ACCESSION NBR: 8609220137 DOC. DATE: 86/09/17 NOTARIZED: NO DOCKET #
 FACIL: 50-275 Diablo Canyon Nuclear Power Plant, Unit 1, Pacific Ga 05000275
 AUTH. NAME AUTHOR AFFILIATION
 SHIFFER, J. D. Pacific Gas & Electric Co.
 RECIP. NAME RECIPIENT AFFILIATION
 VARGA, S. A. PWR Project Directorate 3

SUBJECT: Forwards evaluation of reinstallation of original spent fuel racks, per updated FSAR Chapter 9.

PGandE Letter No.: DCL-86-273

EVALUATION OF
REINSTALLATION OF
ORIGINAL SPENT FUEL RACKS
DIABLO CANYON POWER PLANT UNIT 1

ANCHORAGE RACK NO. 1

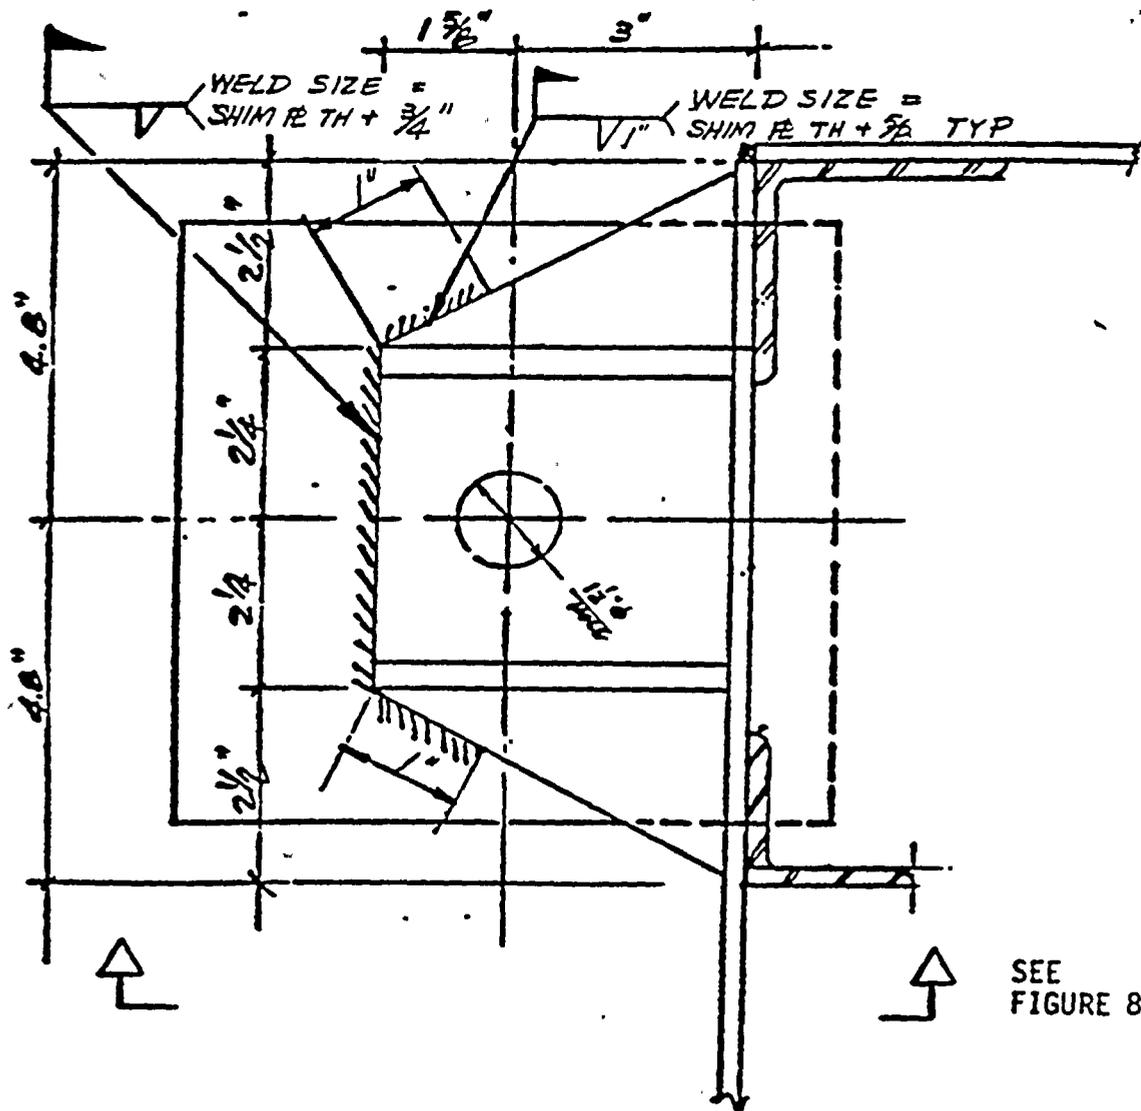
- A. The racks were attached to the plate embedded in the bottom of the spent fuel pool by bolts which were fillet welded to the embedded plate. All forces were transferred to the embed through these fillet welds (Figure 18). Refer to Figures 7 through 9 for details of the revised welded connections.
- B. In lieu of adding weld metal to increase the strength of the connection of diagonal bracing, a 2" x 1-1/4" x 16" bar was welded to the bracing. Refer to Figure 10 for the details of this bar and its attachment to the bracing.
- C. Weld material was added at one gusset plate location on Rack 8 to restore the rack to the original design. Refer to Figure 11 for details.
- D. One cell lacing bar was added on Rack No. 1 to repair damage which occurred during removal of the rack. Refer to Figure 12 for details.

- A. The racks were anchored using welded connections instead of bolted connections because of the increased seismic loading resulting from using the more conservative model used to determine rack stiffness (described in Section 4.1). To facilitate installation of the welded connection, all bolts were ground off, and the embed cavity around each bolt was filled with weld metal and ground flush to achieve an uniform bearing surface (Refer to Figure 9). The load paths due to the revised configuration of the anchorage were evaluated and the results of this evaluation are as follows:

- The welded connection does not change the global load path, since the behavior of the rack module as a truss remains unchanged.
- The welded anchorage changes the local load path on the embeds. The effects of the revised load path were evaluated for 1) the anchor bolt bearing plates at the corner of each rack, 2) the embedded plates at the pool floor, and 3) the headed studs which anchor the plate to the concrete floor.

In all cases, the anchorage components meet the acceptance criteria.

FIGURE 8

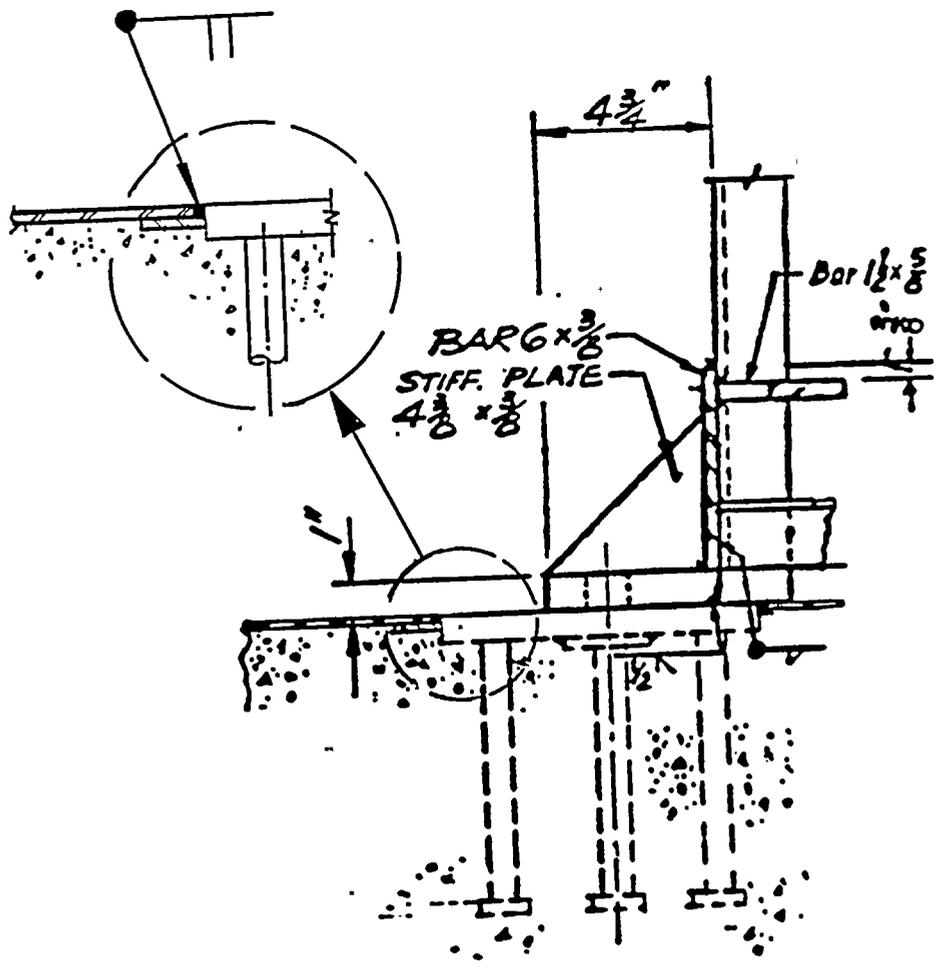
THIS CAVITY TO BE
 FILLED-UP W/ WELD &
 GROUND FLUSH W/ EXIST.
 CUT STUD FLUSH W/
 EXIST.

CUT OFF EXIST. ANCHOR
 PLATE & STIFF

WELD SIZE =
 3/8" R TH + 7/8"

REINFORCEMENT OF BRACING CONNECTION

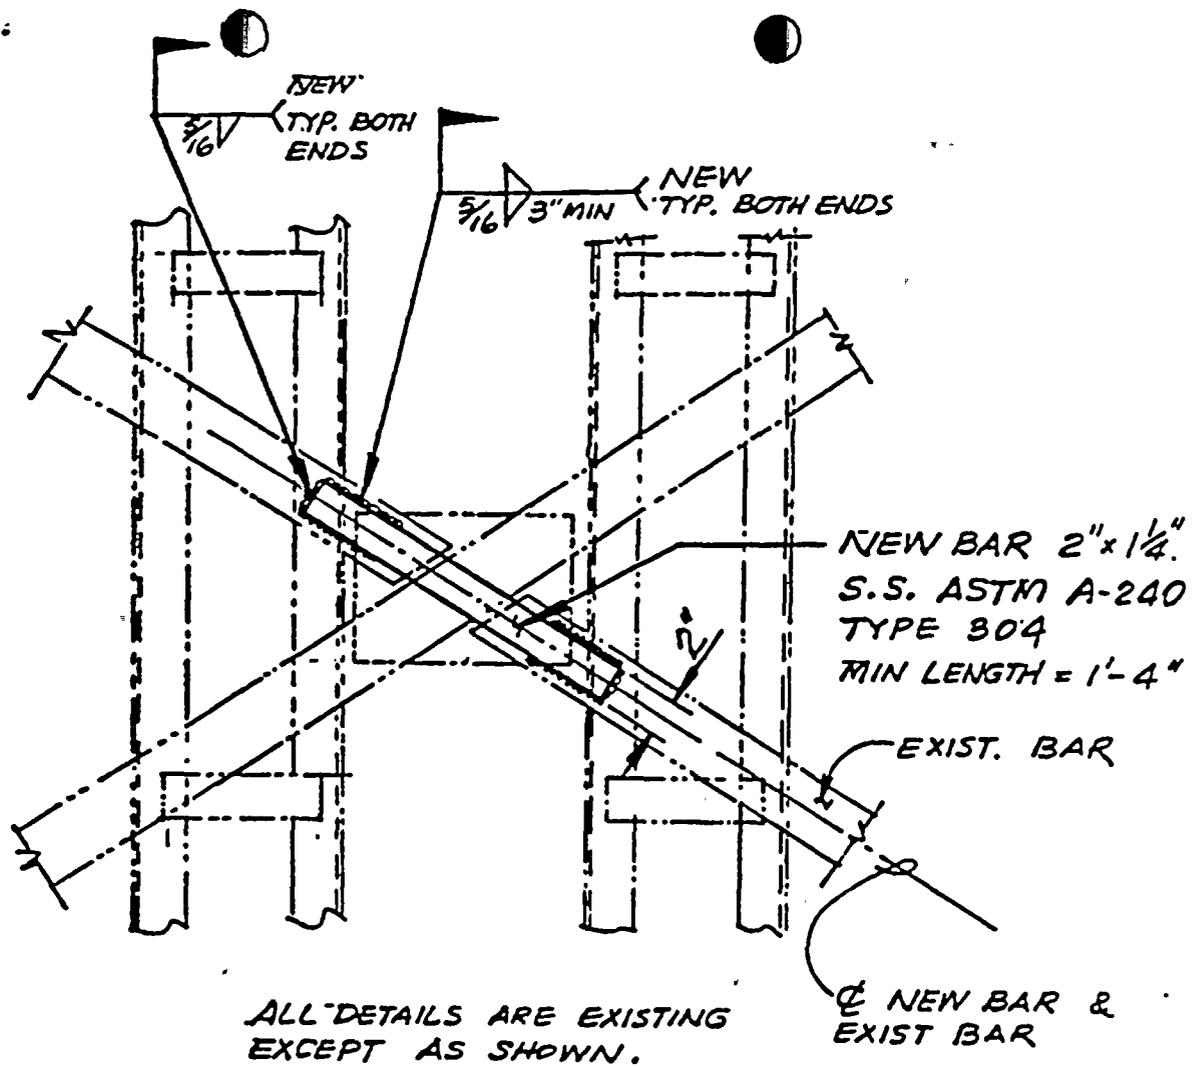
- B. The intersecting connection of the diagonal cross-bracing was reinforced by adding a welded connecting bar (Refer to Figure 10). The change resulted from an as-built review which found that a portion of the weld on the diagonal bracing intersection required by design was not adequate. The as-installed weld met acceptance criteria based on loads determined by the original calculation but not the new more conservative calculation. This bar was installed to provide the strength equivalent to that provided in the original design. This change was chosen for ease of construction and to minimize potential for distortion.

REINFORCEMENT OF BRACING FOR RACK NO. 8

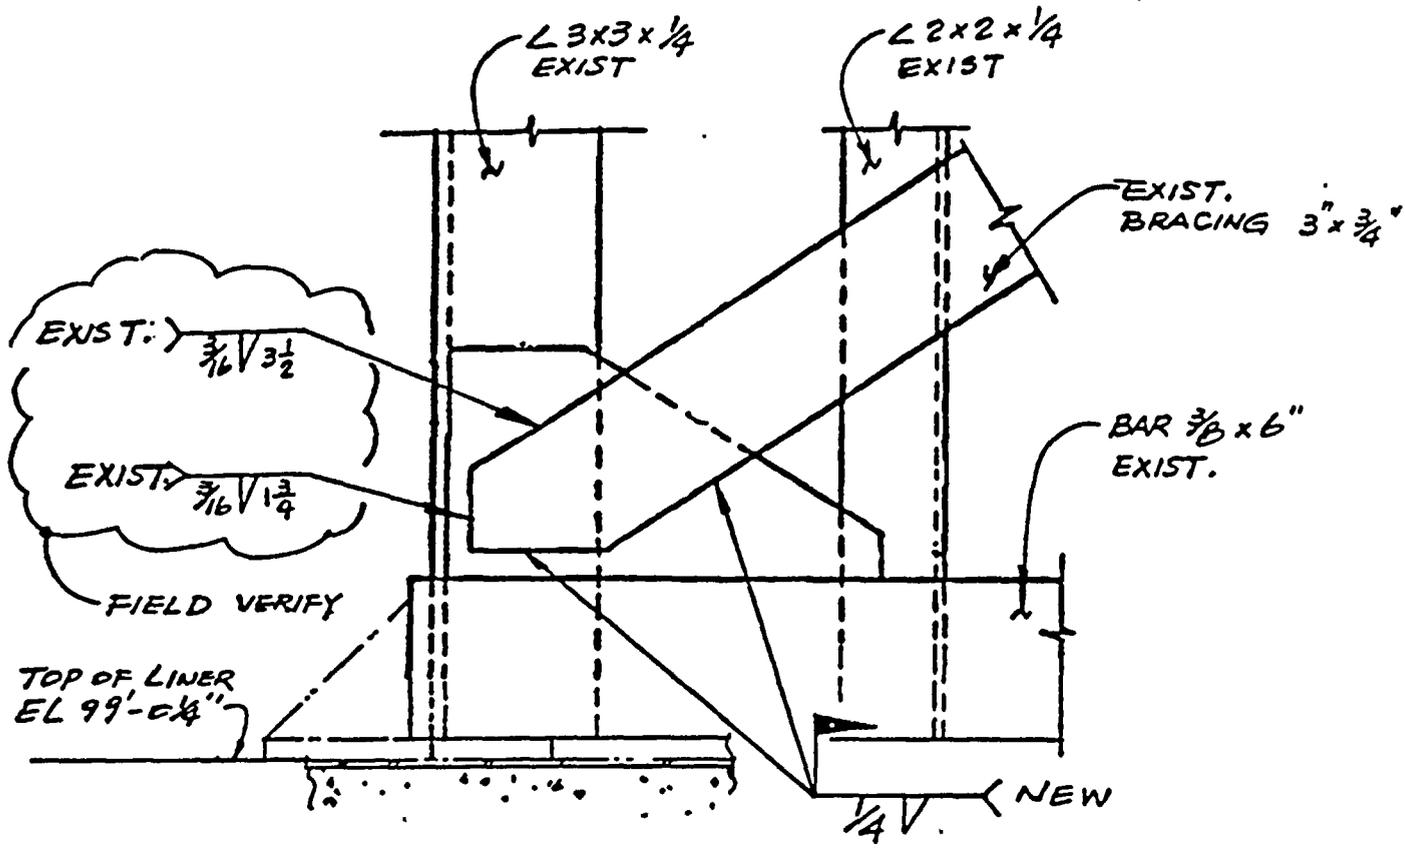
- C. An additional weld was specified at one gusset plate on Rack No. 8 (Refer to Figure 11) for reasons similar to the discussion in Paragraph B. The as-built review found that a portion of the weld required by design had not been provided. The as-installed weld met acceptance criteria based on loads generated by the original calculation but not the new more conservative calculation.

LACING MODIFICATION FOR RACK NO. 1

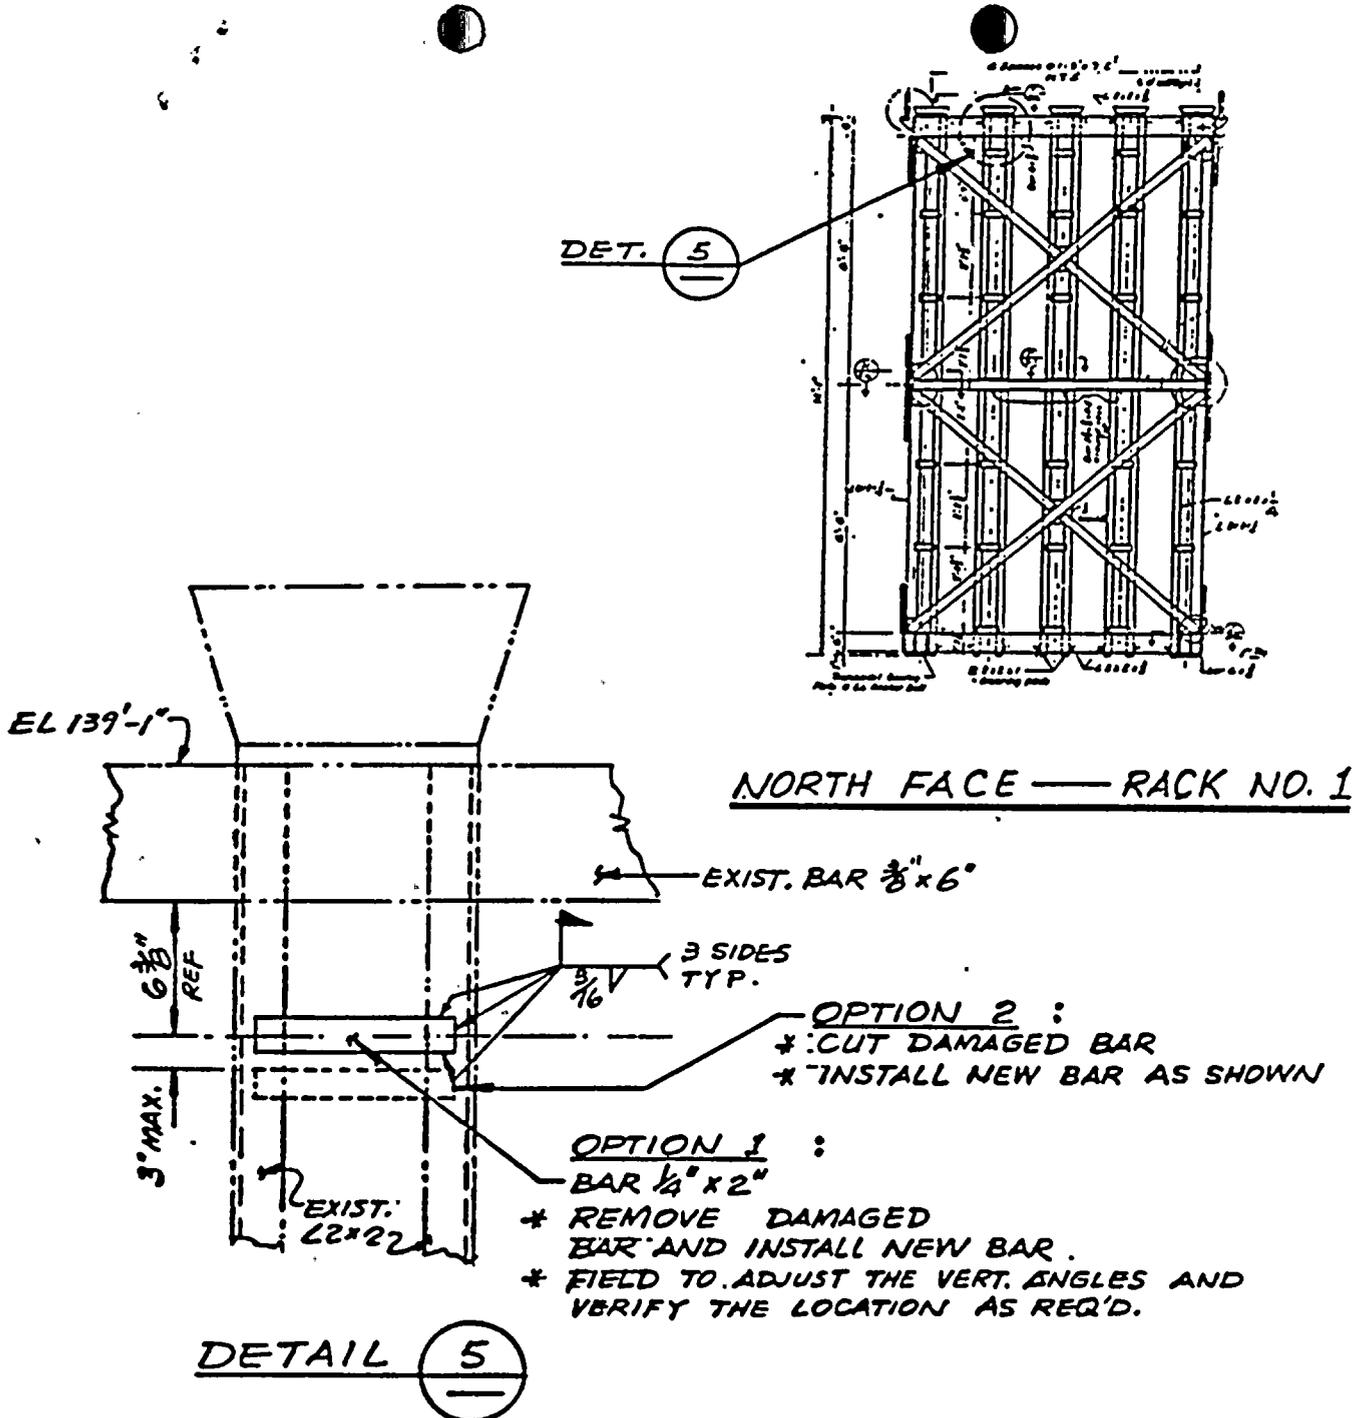
- D. One cell lacing bar was added to Rack No. 1 to repair damage to a lacing bar which was damaged during removal of the racks (Refer to Figure 12). The effects of the revised location of the lacing bar on the cell (local buckling) have been evaluated.

**FIGURE 14
PROPOSED FSAR CHANGE**

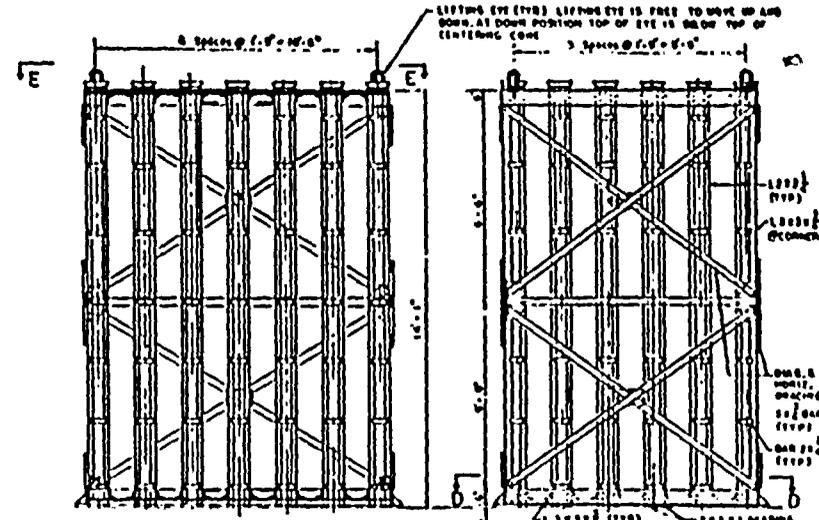
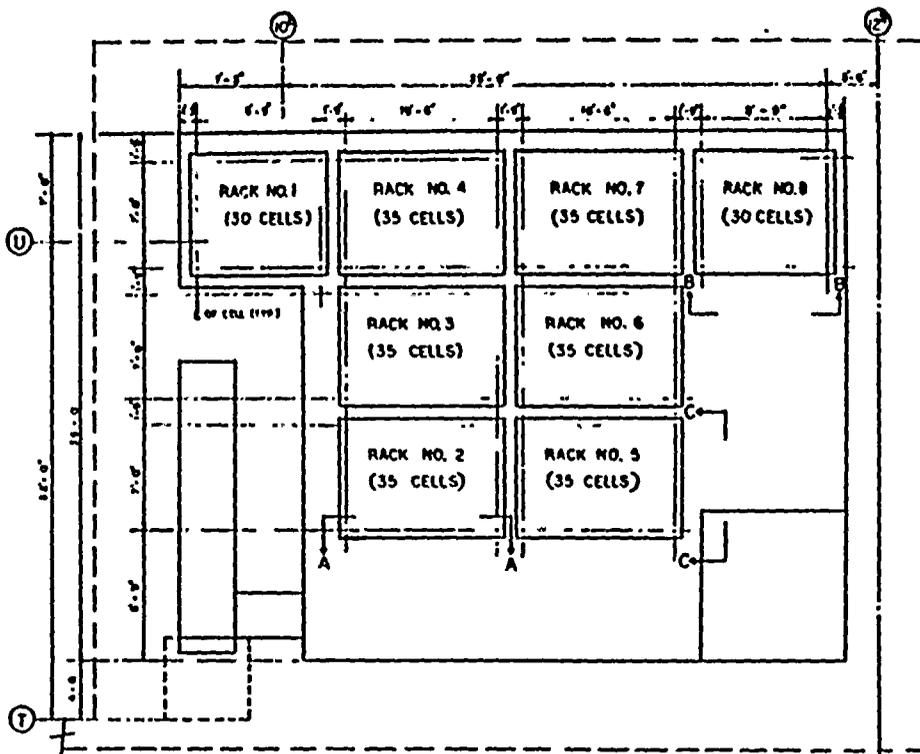
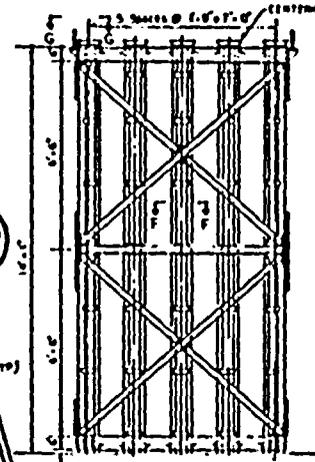
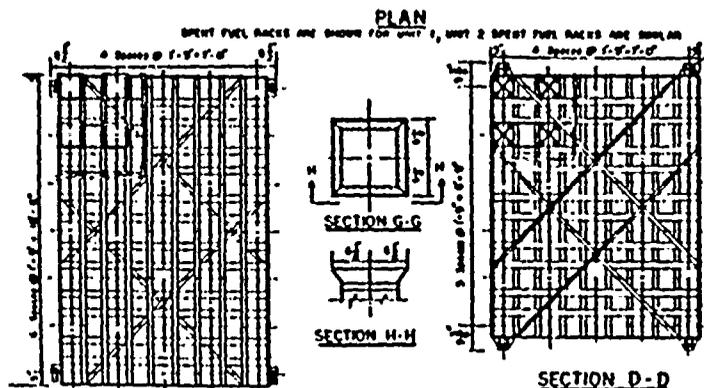
The changes to the FSAR resulting from the revised calculations and as-builts are minor. Figure 9.1-2 of the FSAR will be changed by revising the note to indicate attachment by welding instead of bolting. In the next FSAR Update in accordance with 10 CFR 50.71(e), the note making reference to a one-inch diameter bolt will be revised to reflect the welded anchorage. Figures 14 and 15 show the proposed change.

ORIGINAL BOLTED CONNECTION

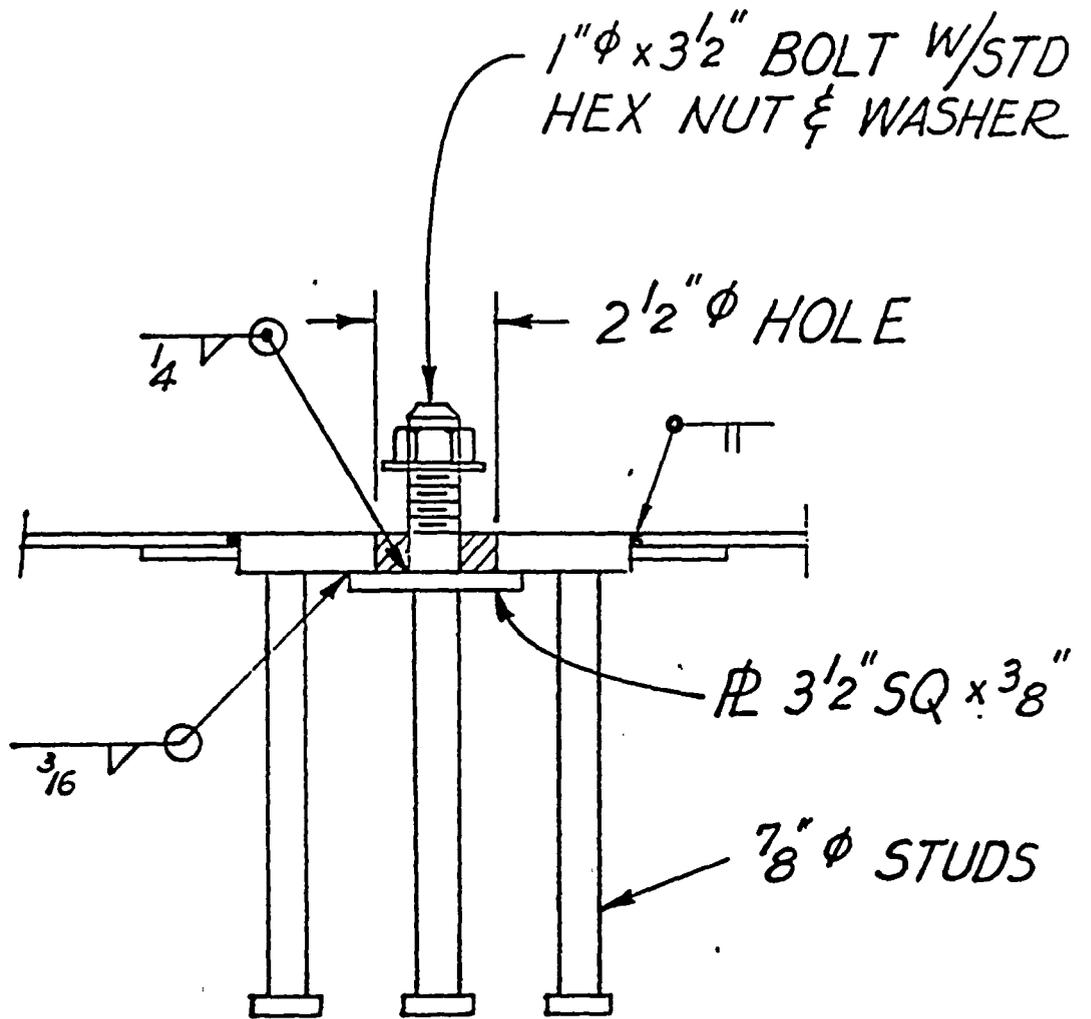
The welded attachments have been shown to provide anchorage properties equivalent to or better than the original bolting arrangement which depended upon a fillet weld to the embed for load transfer; therefore they would create no accidents or malfunctions different from those previously evaluated in the FSAR.
